**NORTHEAST UTILITIES**

Docket No. 50-423  
B11332

Millstone Nuclear Power Station, Unit No. 3  
Use of Alternative Damping Criteria

## MNPS-3 FSAR

Figure 3.7B-71

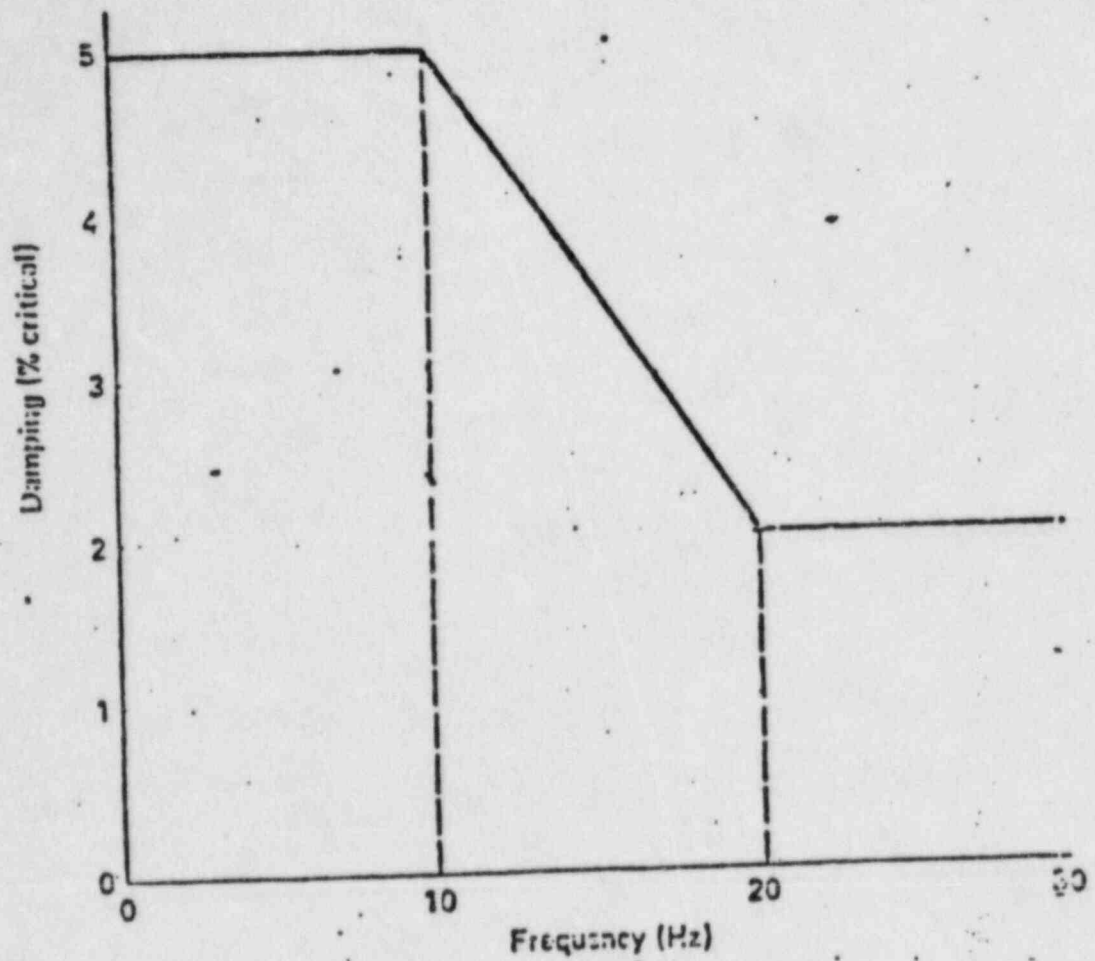
Obtained for discrete locations in the structure where the piping systems are supported. Enveloping and peak broadening procedures are applied on these ARS curves before input, as described below. Damping values used for piping are 0.5 percent for OBE and 1 percent for SSE (Section 3.7B.1.3), except that increased damping values may be applied on an as-needed basis for final stress reconciliation (or piping system backfits) in accordance with ASME Code Case N-411 (Figure 3.7B-71).

\* For final reconciliation of pipe stress analysis or piping system backfits damping values as defined in ASME Code Case N-411 (Figure 3.7B-71) may be utilized for both OBE and SSE.
